TDK Corporation

Process Change Notice

Notification for Dummy Pattern Abolish for Chip NTC Thermistors

2. Dummy pattern abolish and target products

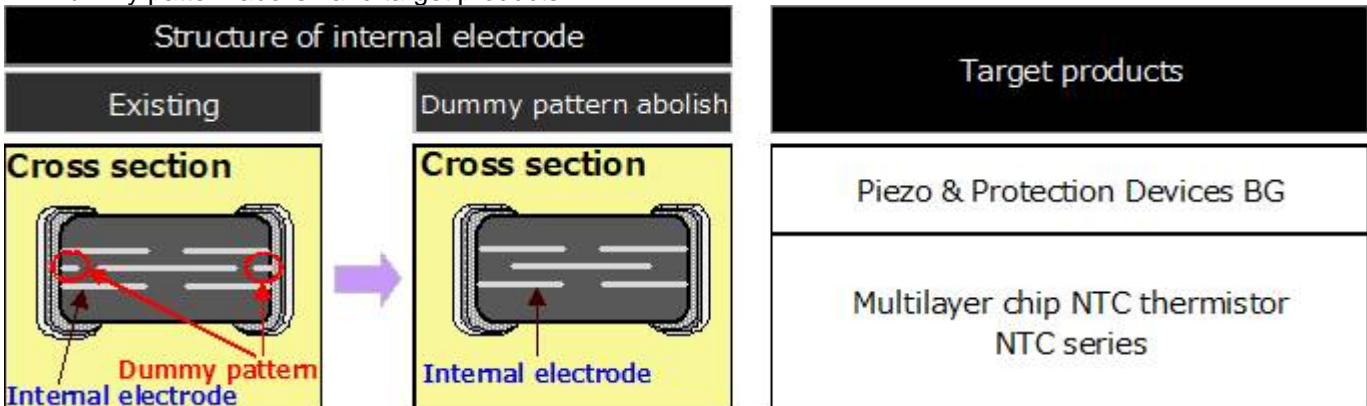
In response to the recent trend of increasing global demand for palladium, we have decided to abolish the dummy pattern that do not affect product characteristics, in order to ensure a stable supply of our chip NTC thermistors.

There is no change in product name, specifications (appearance, dimensions, electrical characteristics), reliability, process control plan, etc.

Dummy electrode abolish have already been adopted for our new products, and we have some their shipment. We would like to inform you that we would like to apply the dummy pattern abolish even in the existing products that we have already provide.
